Office Action Summary

10/597,200

DETAILED ACTION

FIG. 8.

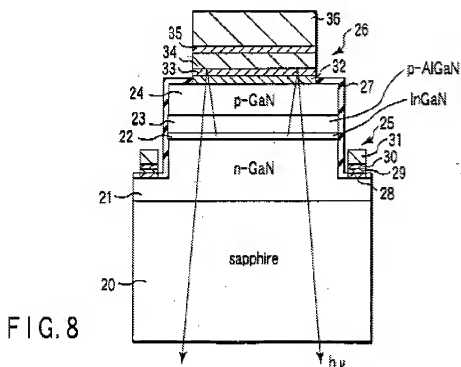
With regard to claim 1, Slater 721 discloses (the abstract, fig 8,fig 7) a gallium nitride-based III-V group compound semiconductor device comprising; a p-type ohmic electrode layer (paragraph [0022] , Slater 721 discloses that all of his embodiments are complementary ; i.e. include p-type or n-type) formed on the gallium nitride-based semiconductor layer(fig 7,fig 8, layer 30) wherein the p-type ohmic electrode layer comprises a contact metal layer (layer 32 fig 8, fig 7) a reflective metal layer(fig 8,fig 7 layer 34, the abstract, paragraph [[0041]and a

diffusion barrier layer.(fig 8, fig 7 layer 36, the abstract, paragraph [0041], the reflective metal layer (fig 8 layer 34) being disposed between the contact metal layer (fig 8,fig 7) layer 32) and the diffusion barrier layer (fig 8 layer 36)

With regard to claim 2, Slater 721 discloses a Gallium Nitride device wherein the p-type ohmic electrode layer further comprises at least one bonding metal layer (fig 8,],paragraph [0098]).

With regard to claim 3, Slater 721 discloses a Gallium Nitride device (fig 7 combined layer 55+60, fig 8 combined layer 55+60)), wherein the p-type ohmic electrode layer is formed by sequentially laminating the contact metal layer (fig 8,fig 7 layer 32,) the reflective metal layer,(fig 8,fig 7 layer 34) the diffusion barrier layer (fig 8 ,fig 7 layer 36) , and the bonding metal layer fig 8 combined layer 55+60,fig 7 combined layer 55+60)

With regard to claim 4, Slater 721 discloses a Gallium Nitride device wherein the contact metal layer comprises at least one of Ni, Ir, Pt, Pd, Au, Ti, Ru, W, Ta, V, Co, Os, Re, and Rh. (fig 7,fig 8 , paragraph [0041].

With regard to claim 5, Slater 721 discloses a Gallium Nitride device wherein the reflective metal layer comprises at least one of Al and Ag (fig 8 , fig 7 layer 34 , paragraph [0041]note that Slater 721 discloses that layer 34 can be made of Aluminum or silver..

With regard to claim 7, Slater 721 discloses the invention of a gallium nitride device wherein the bonding metal layer comprises first and second bonding metal layers, said first bonding metal layer (,fig 8 , layer 55, fig 7 layer 62 or 55) comprising at least one of Ni, Cr, Ti,

Pd, Ru, Ir, Rh, Re, Os, V, and Ta, said second bonding metal layer (fig 8 layer 60, fig 7 layer 62 or 64) comprising at least one of Au, Pd, and Pt. (paragraph [0049],[0058],[0059])
